TAYLOR POINTE SUBDIVISION, UNIT TWO

This is a request for a one-year extension of a previously approved 50-lot / $20.1\pm$ acre subdivision. The subdivision is located at the West terminus of Taylor Pointe Drive.

DETAIL SITE PLAN

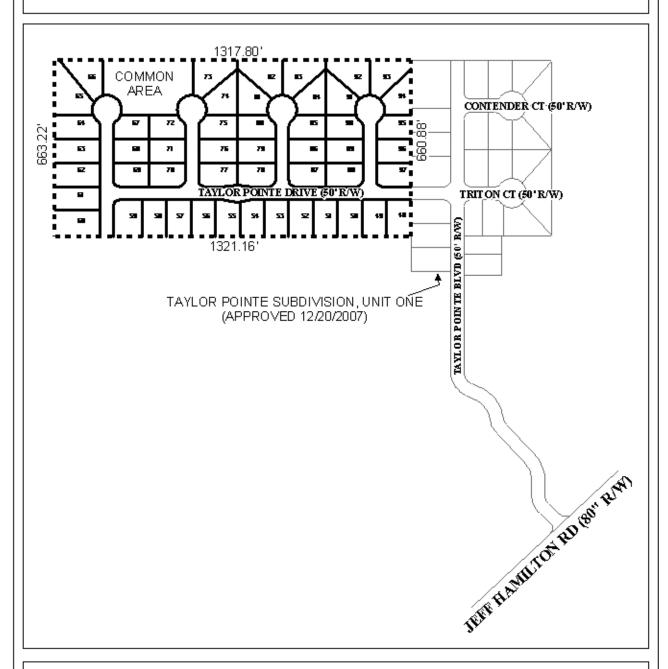
This is the first request for an extension since the subdivision was originally approved in February, 2008. There have not been changes in conditions in the surrounding area that would affect the subdivision as previously approved. However, since the original approval, the Subdivision Regulations have been amended to include the 2003 International Fire Code (IFC) standards for street construction, specifically standards for cul-de-sac diameters. Those standards require cul-de-sacs without a central median to be 120' minimum right-of-way diameter. Since the proposed subdivision contains cul-de-sacs without a central median of 100' diameter, the cul-de-sacs should be revised to 120' diameter to meet the adopted 2003 IFC standard.

1) revision of the cul-de-sacs right-of-way diameter to 120' to comply with the 2003 International Fire Code standards.
